From: [REDACTED]
Sent: 02 January 2020 12:08
To: Sian Eggington
Subject: RE: BE/134/19/HH
Attachments: We sent you safe versions of your files; Proposed.pdf
Categories: Green Category

From: Sian Eggington <Sian.Eggington@TerraQuest.co.uk>
Sent: 24 December 2019 11:53
To: [REDACTED]
Subject: RE: BE/134/19/HH

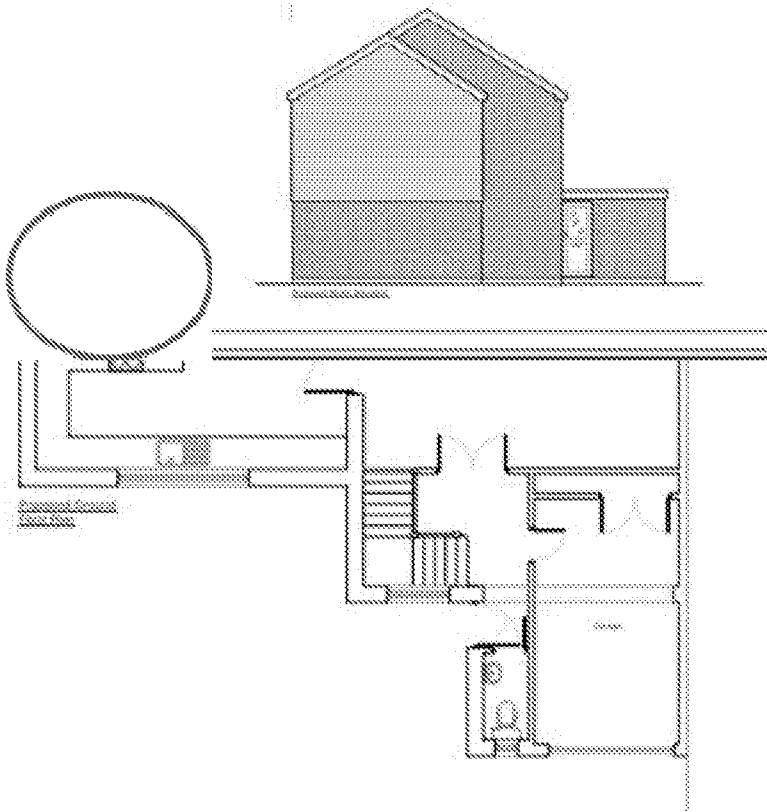
The north elevation shows the door entering what would be the garage but the floor plan is showing the door entering the bathroom. Which wouldn't be visible on that elevation.

The door on the proposed north elevation is in the wrong position in relation to the proposed ground floor plan. The position the door is in wouldn't be seen on the elevation as its opening from the bathroom outwards not the garage outwards.

Please see attached plan with the door and opening marked in red, showing the front door opening into the hallway not the garage

It's the front door to the house? It's shown opening inward on plan it's quite correct
